Wollongong Local Planning Panel Assessment Report | 5 May 2022

WLPP No.	Addendum Report to WLPP Item 2 – 8 February 2022
DA No.	DA-2021/1310
Proposal	Residential – demolition of existing buildings, remove eight (8) trees, construction of multi dwelling housing – eight (8) units and Subdivision – Strata title – eight (8) lots
Property	14-16 Acacia Avenue, Gwynneville
Applicant	10 Star Pty Ltd
Responsible Team	Development Assessment & Certification – City Centre Team (BH)

ADDENDUM REPORT

TITLE:
LANDSCAPE AND SITE COVERAGE PLAN

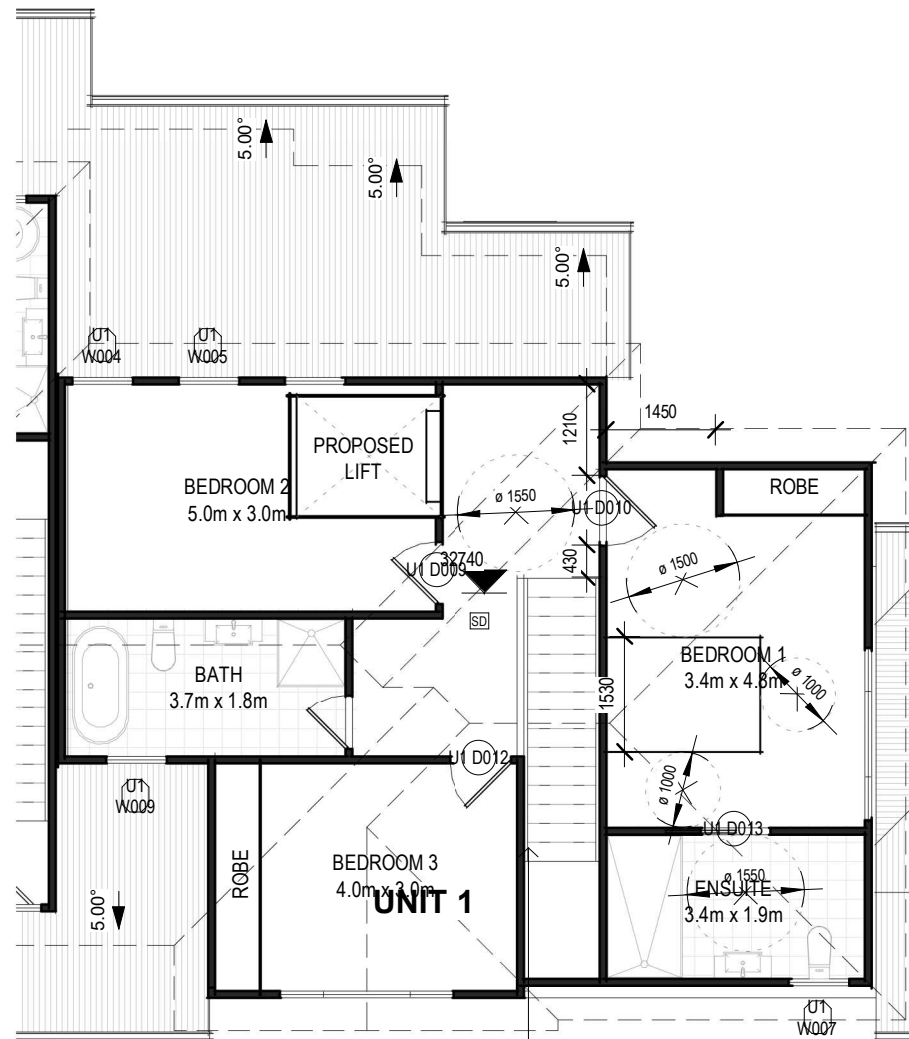
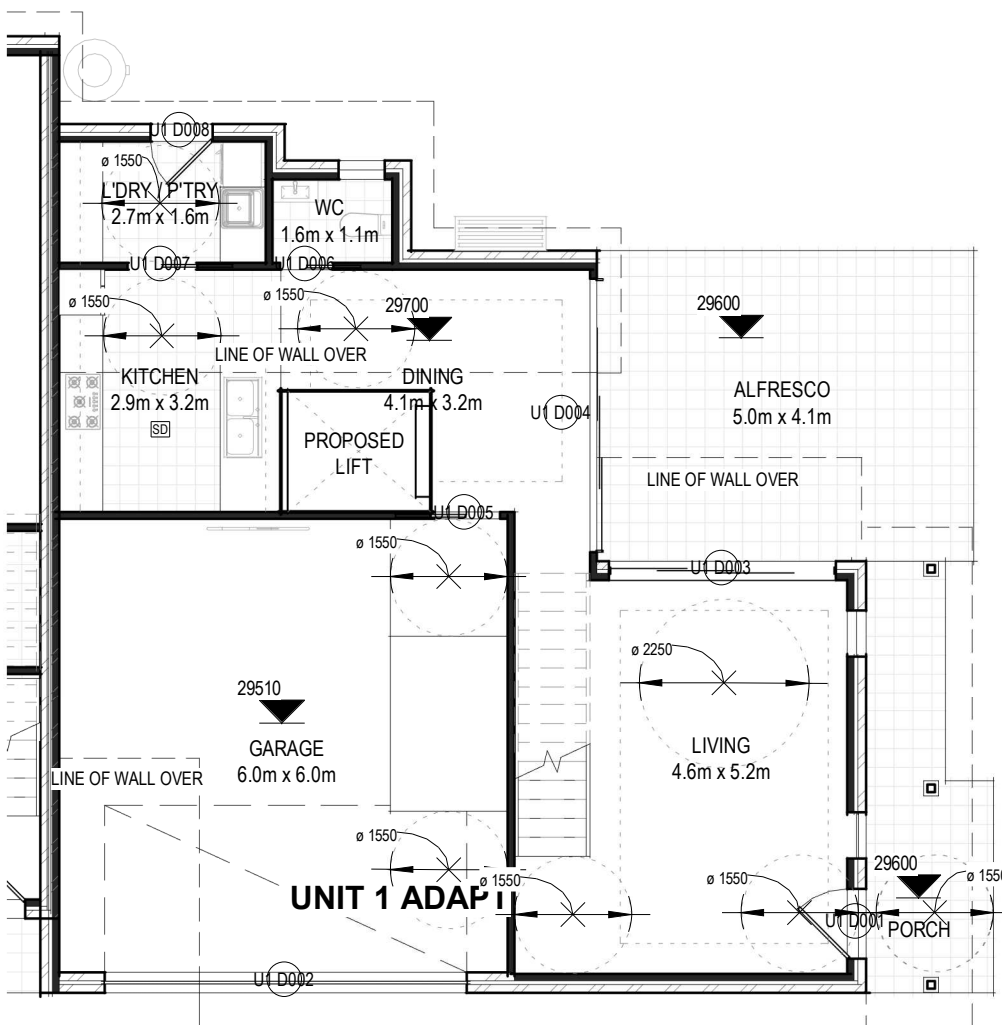
- ***Introduce landscaping along the central driveway to provide relief to the extent of hard surface.***

Landscape beds have been added to the driveway as requested. The minimum 5m driveway width is maintained and turning circles provided to demonstrate that access to and from garages is not impeded. (see Sheet 22 and Landscape Plan).

The amended landscape plan is considered to provide an appropriate degree of softening to the central driveway.

SHEET:	U5-8 POS SHADOWS				ISSUE:
PROPOSAL:	Proposed Multi Dwelling Development and Strata Title Subdivision		DATE:	11/03/2022	Checker
CLIENT:	R.Heckenberg		SCALE @ A3:		
ADDRESS:	14 - 16 ACACIA AVENUE, GWYNNEVILLE, 2500		PROJECT NO:	10STAR-066	SHEET:
LGA:	DA ISSUE		DRAWN BY:	Author	31

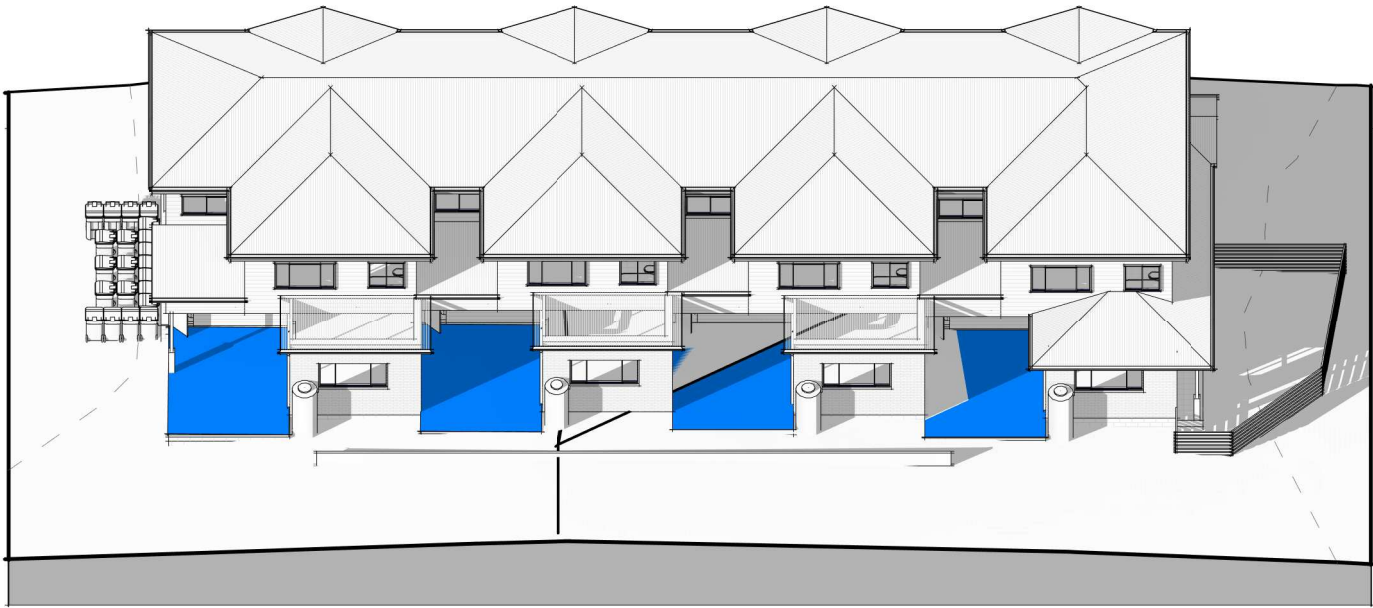
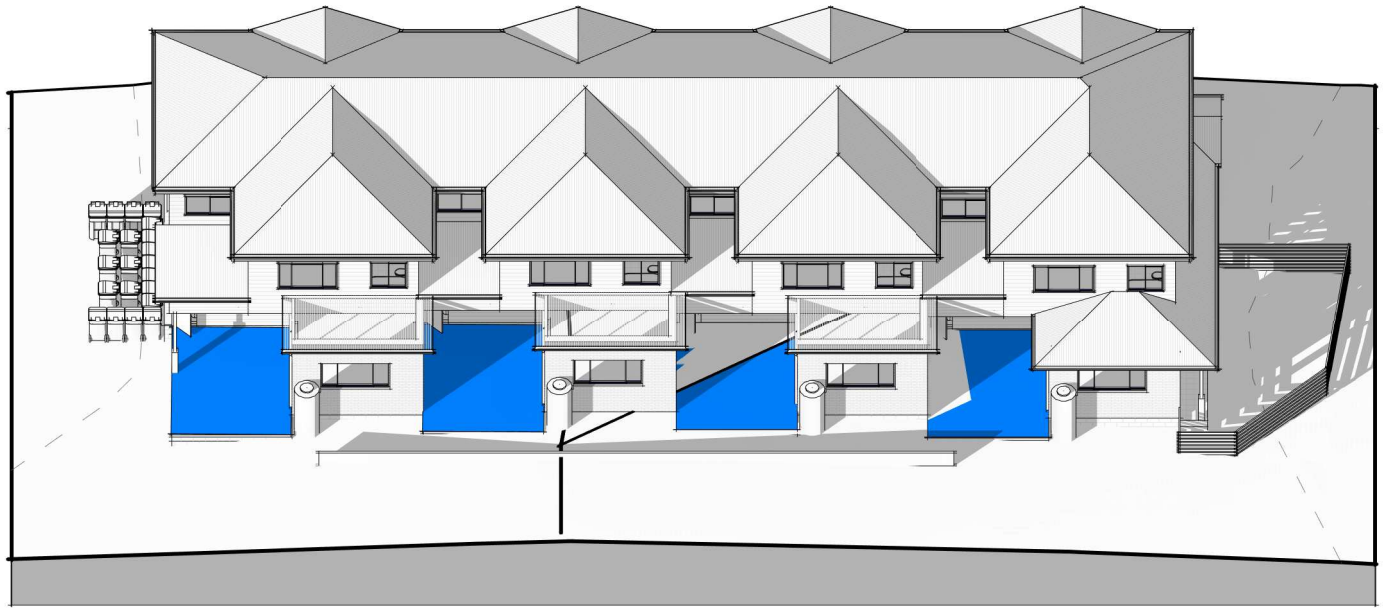
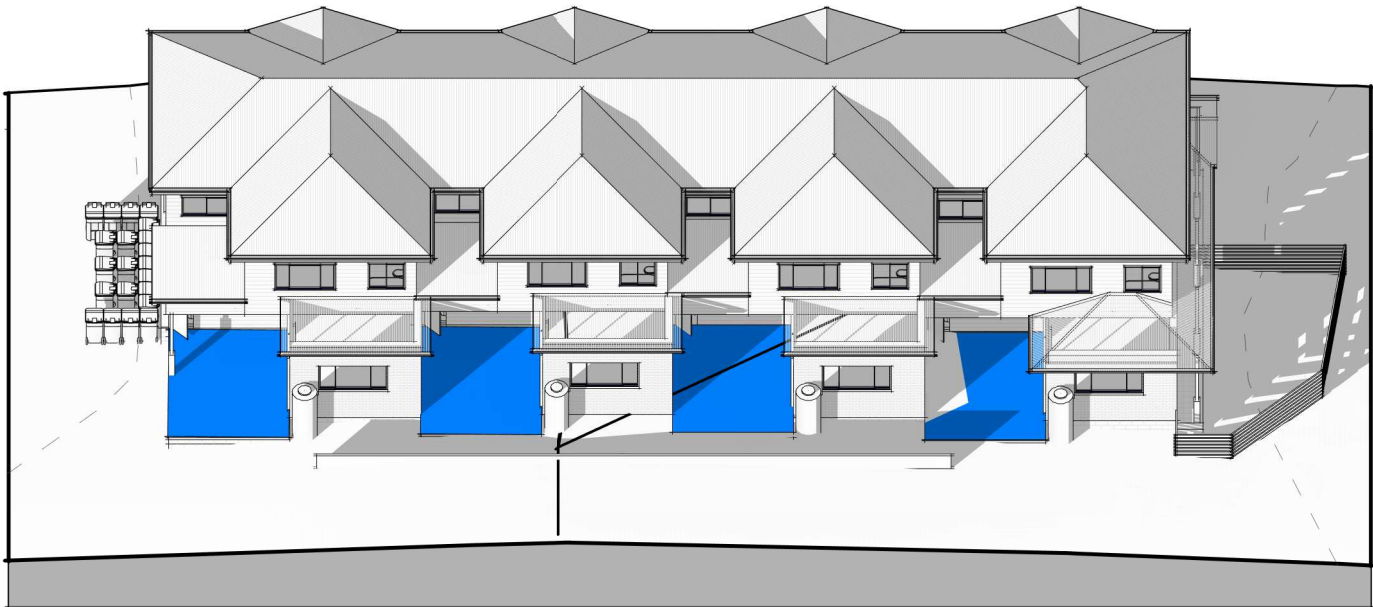
- ***Demonstrate that private open space and living areas achieve three hours of solar access. Sun eye diagrams will be required.***

Shadow Diagrams have been provided showing that 100% of the Units receive the minimum 3hours of sunlight required during 9am – 3pm (see Sheets 27 – 31)

The shadow diagrams are not in the form of sun eye diagrams as requested as the applicant does not have the required software to generate such diagrams. The shadowing is demonstrated on perspective drawings and coloured to clarify the extent of solar access to courtyards and living areas. Council's architect has reviewed the submitted diagrams and confirms that the solar access provisions of WDCP 2009 are satisfied.

SHEET:	ELEVATION PERSPECTIVE				ISSUE:	
PROPOSAL:	Proposed Multi Dwelling Development and Strata Title Subdivision			DATE:	11/03/2022	DA-006
CLIENT:	R.Heckenberg			SCALE @ A3:		
ADDRESS:	14 - 16 ACACIA AVENUE, GWYNNEVILLE, 2500			PROJECT NO:	10STAR-066	SHEET:
LGA:	DA ISSUE			DRAWN BY:	M.LISICA	32

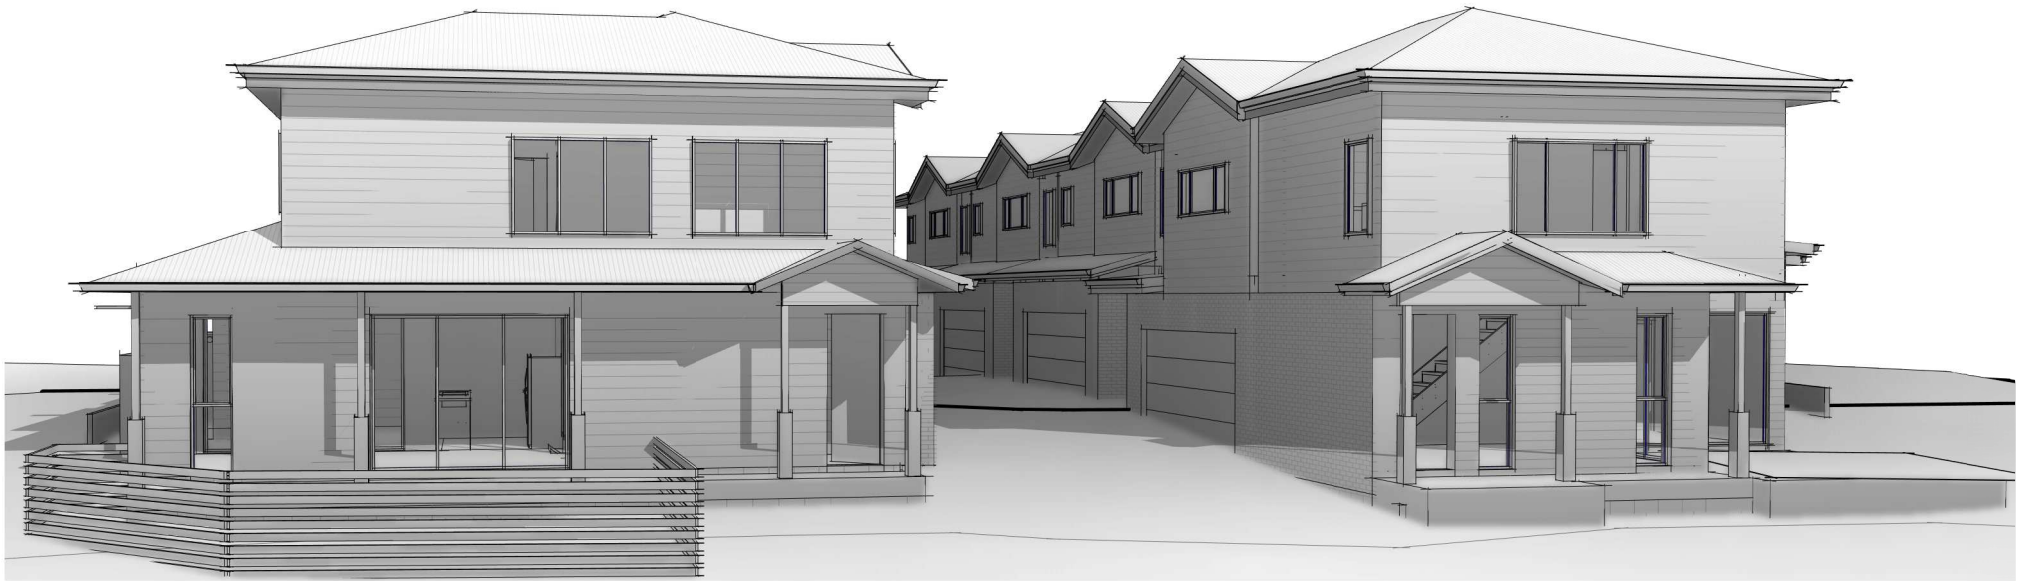
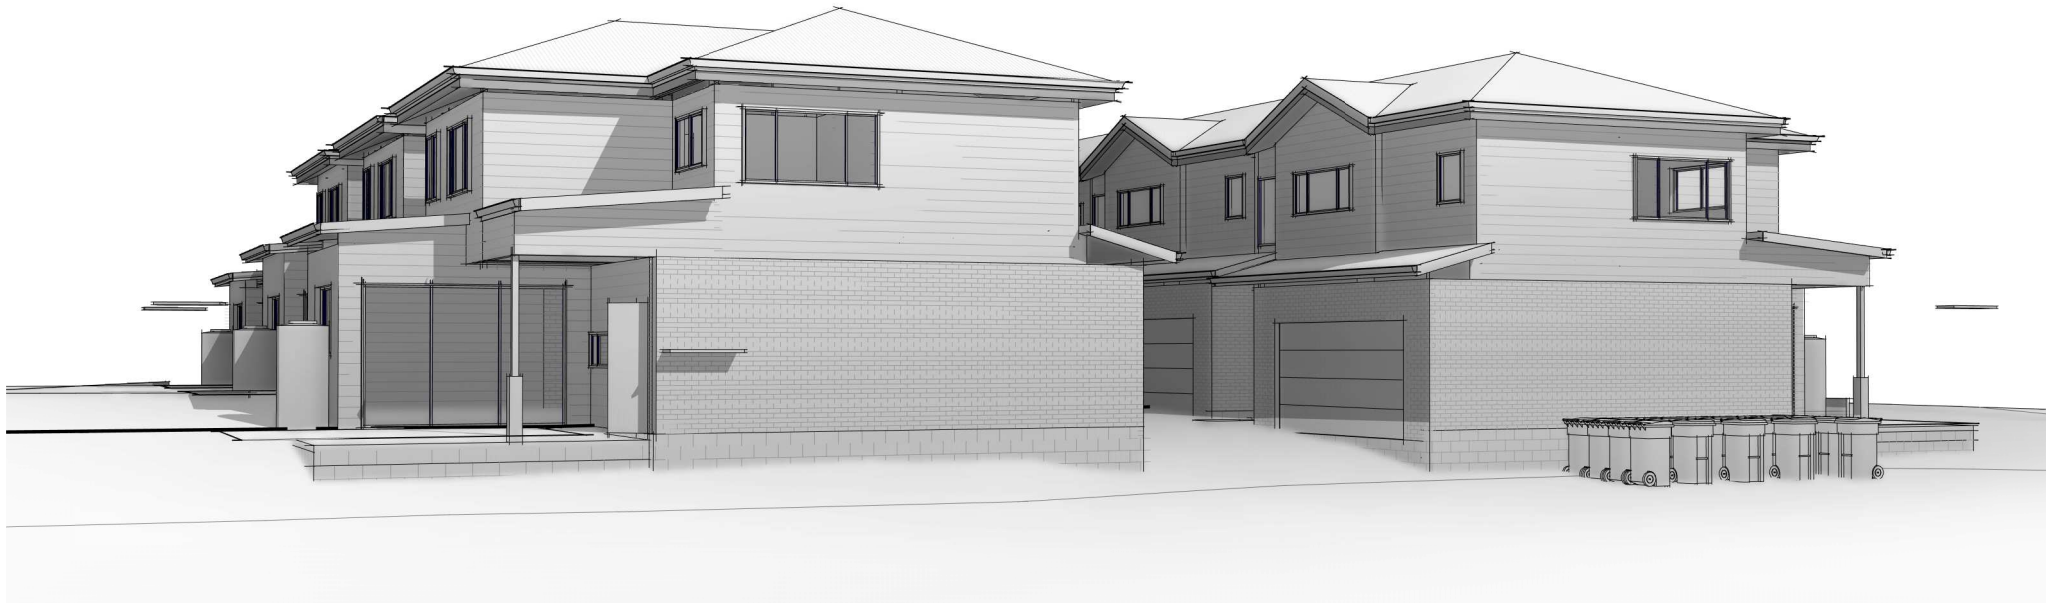
- ***To improve streetscape to include windows to the southern elevation.***

Additional windows have been added to Unit 5 facing the street which will match Unit 1 as well as the rest of the sliding windows along the first floor.

The revised plans provide an appropriate streetscape appearance and are considered acceptable.
